COMMERCIAL AVENUE SANITARY SEWER RECONSTRUCTION

CITY PROJECT NO. 14921
CONTRACT NO. 9486

ADDENDUM #3: 9/3/2024

REVISION #2: 12/2/2024

14921	MADISON, WI	9486	U-3B
SEWER PLAN AND PROFILE - PROPOSED HWY 30 CROSSING		CONTRACT NO.:	
COMMERCIAL AVENUE SANITARY SEWER RECONSTRUCTION		14921	
M:\DESIGN\Projects\14921\CAD\Sewers\14921SWR-PipeNetwork.dwg		U-3B	
		14921 U-3B

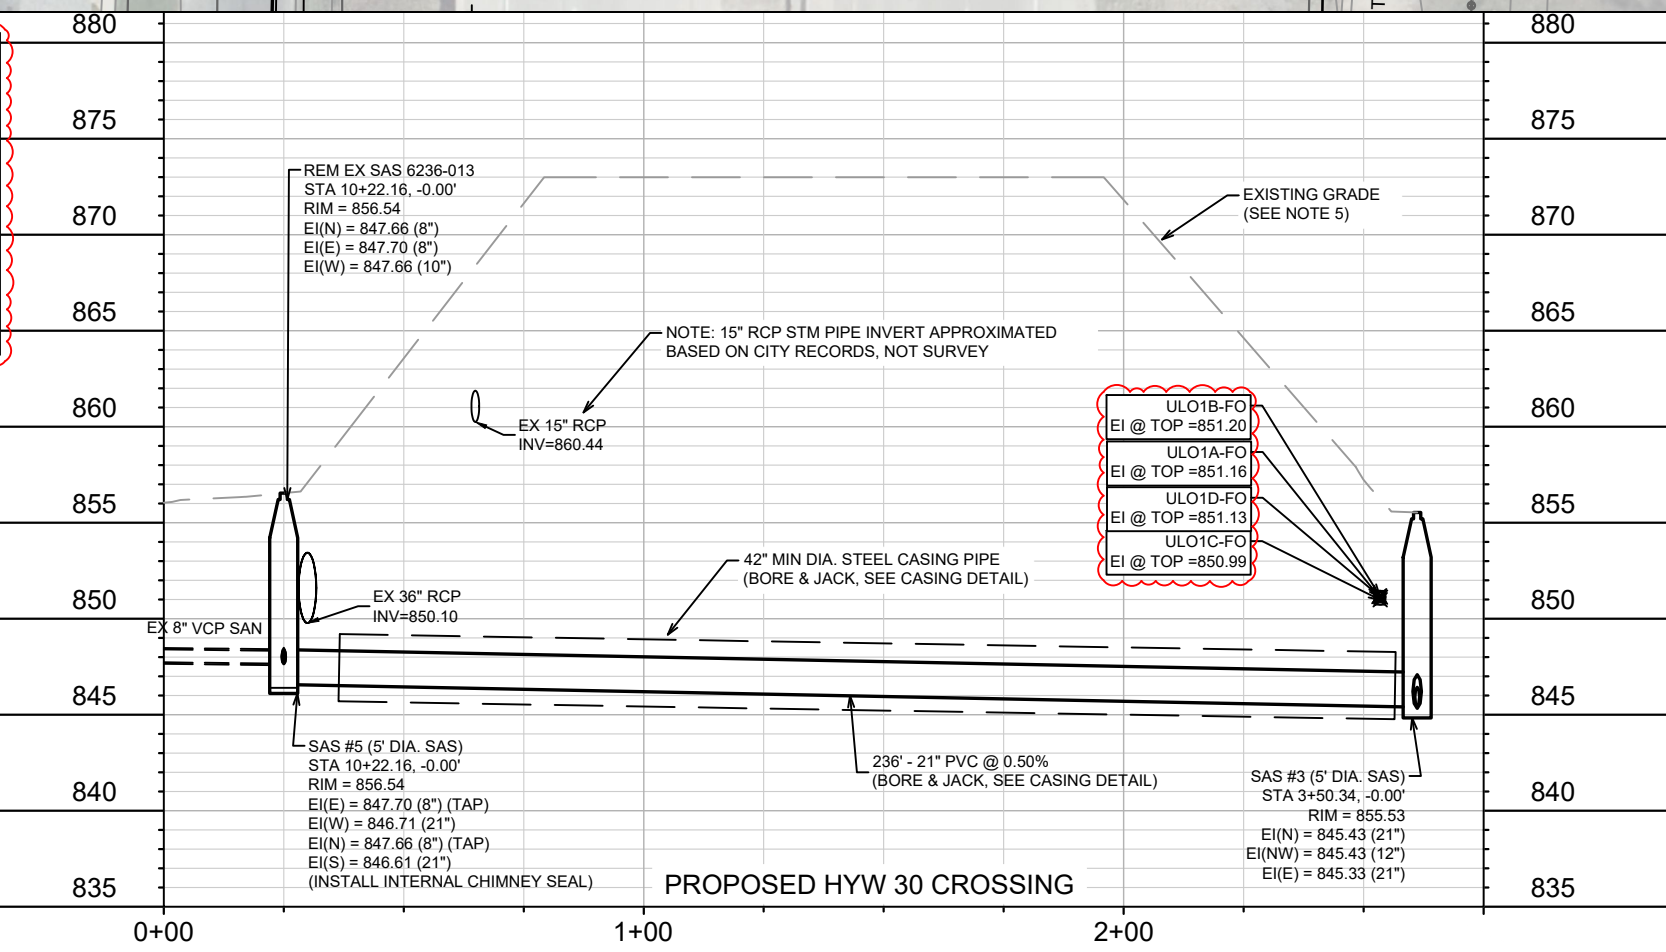
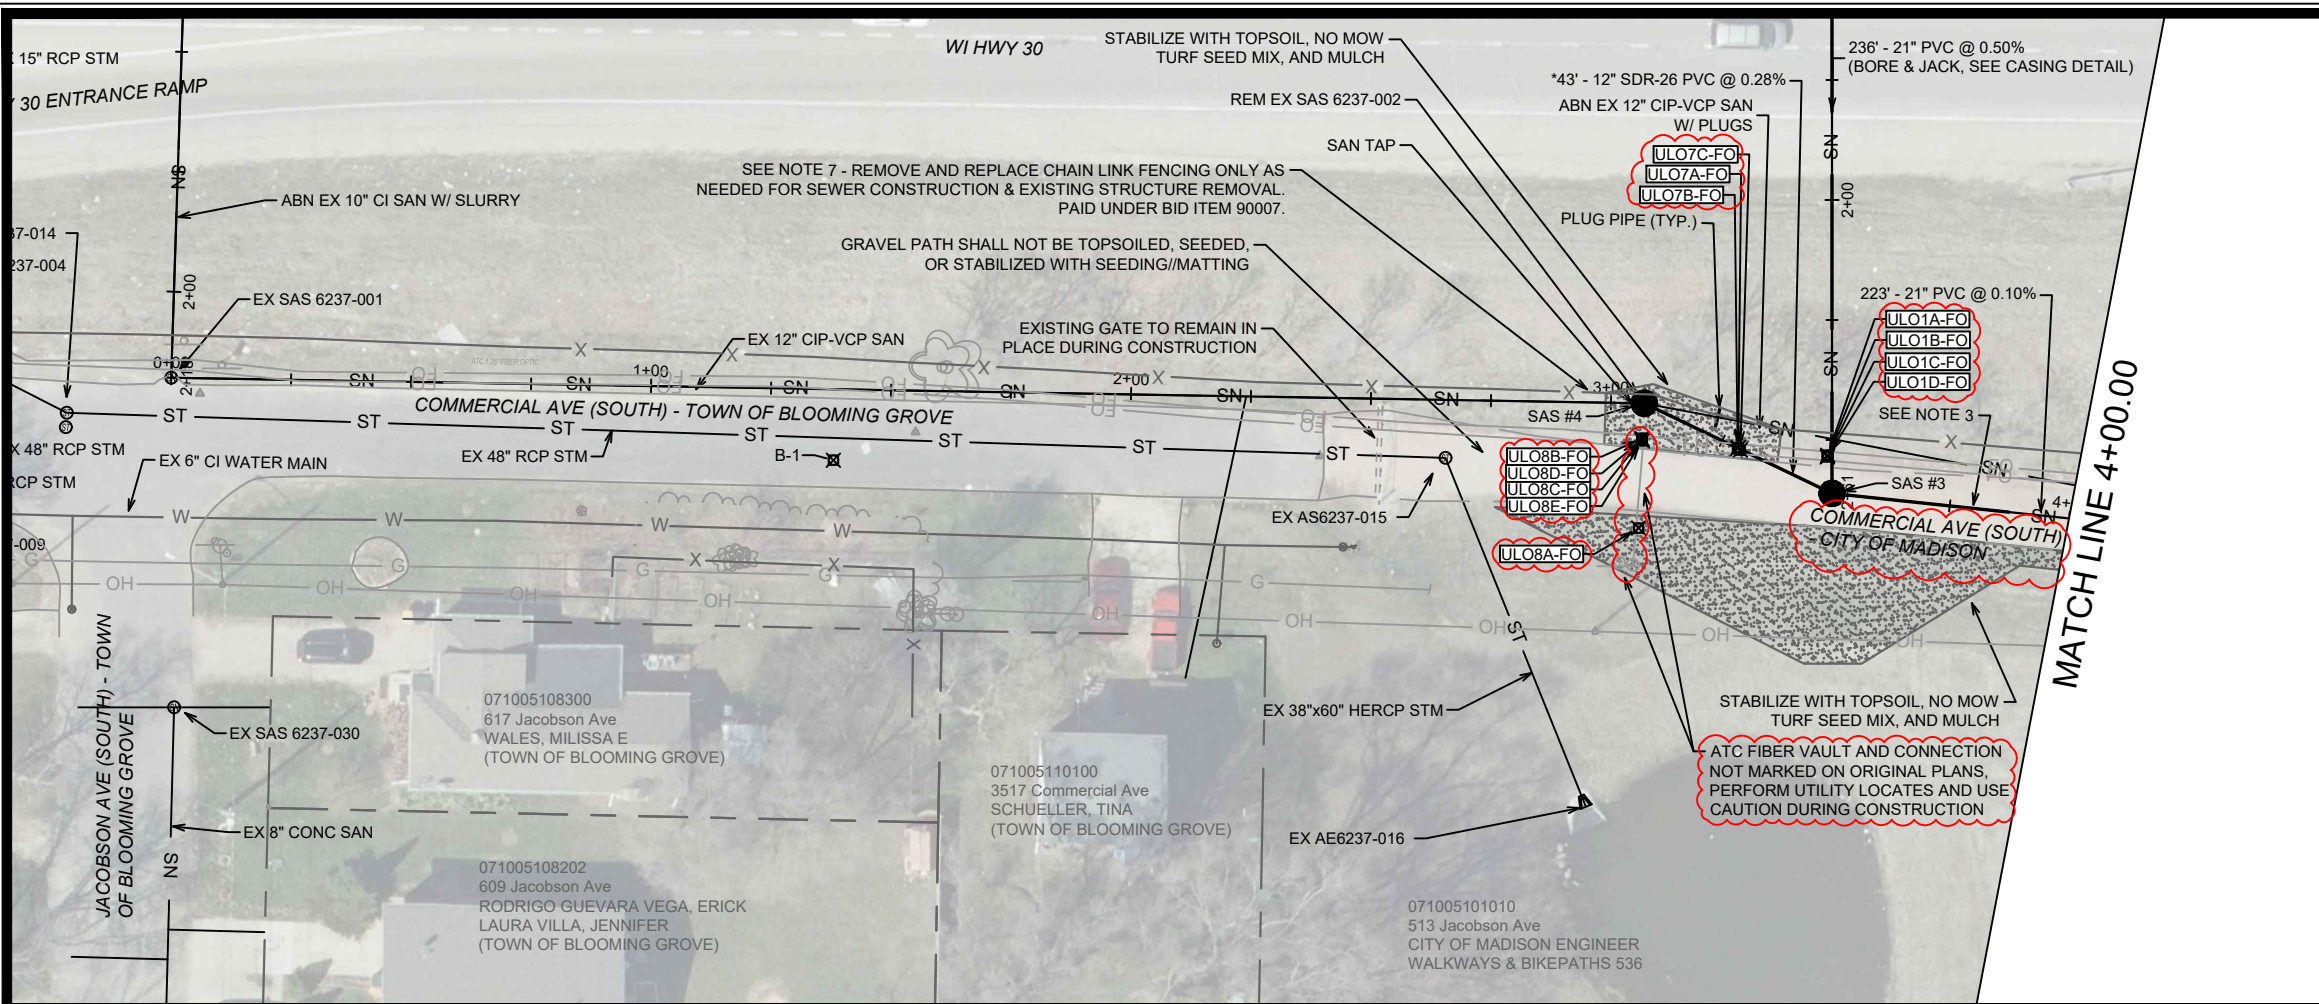
REVISION #2: 12/2/2024
 1. ULO DATA ADDED. DESIGN MODIFIED AS NEEDED (U-1, U-2, U-3B, & U-5)
 2. SAS #6 OUTSIDE DROP REMOVED, REPLACED WITH TAP (U-3 & U-4)
 3. SAS #4 TAP CORRECTED IN PROFILE (U-5)

14921	U-5
14921	U-5
MADISON, WI	U-5
14921	U-5
9486	U-5
CONTRACT NO.:	U-5
SEWER PLAN AND PROFILE - SOUTH COMMERCIAL AVENUE	U-5
COMMERCIAL AVENUE SANITARY SEWER RECONSTRUCTION	U-5
M:\DESIGN\Projects\14921\CAD\Sewers\14921SWR-PipeNetwork.dwg	U-5
	U-5
14921	U-5
U-5	U-5

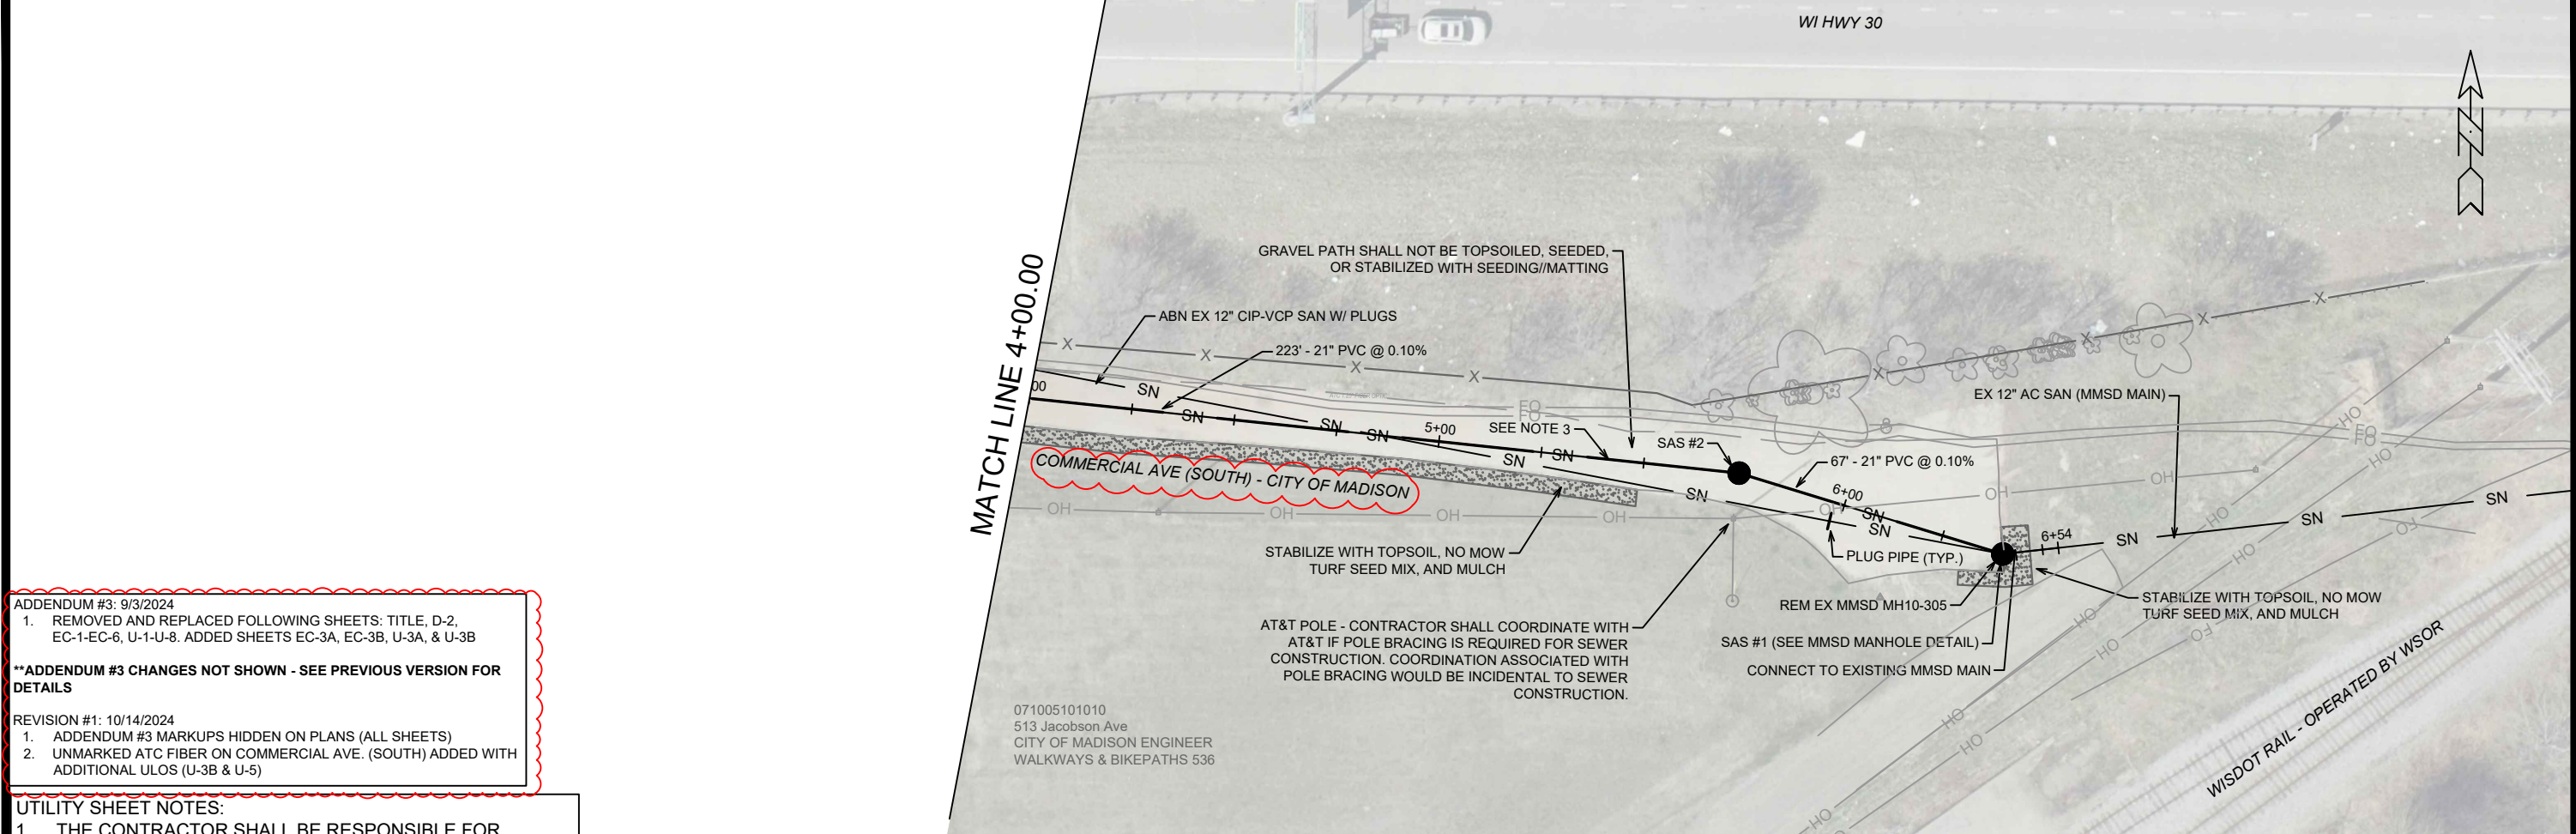
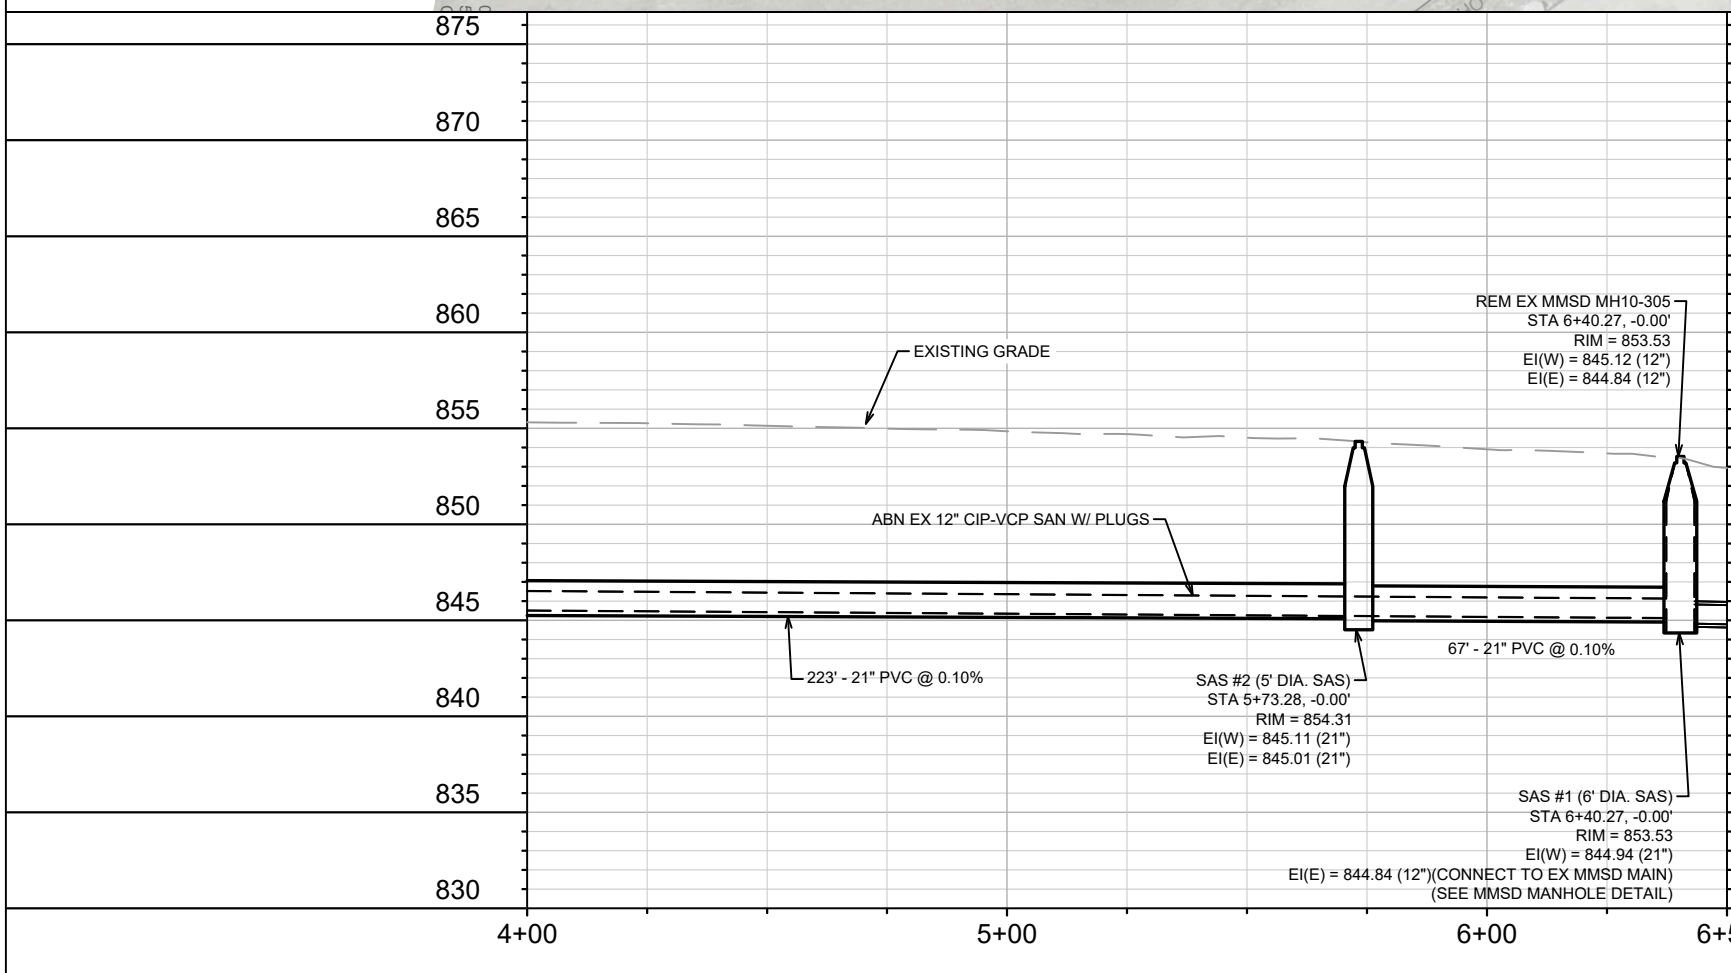
REVISION #2: 12/2/2024
 1. ULO DATA ADDED, DESIGN MODIFIED AS NEEDED (U-1, U-2, U-3B, & U-5)
 2. SAS #6 OUTSIDE DROP REMOVED, REPLACED WITH TAP (U-3 & U-4)
 3. SAS #4 TAP CORRECTED IN PROFILE (U-5)
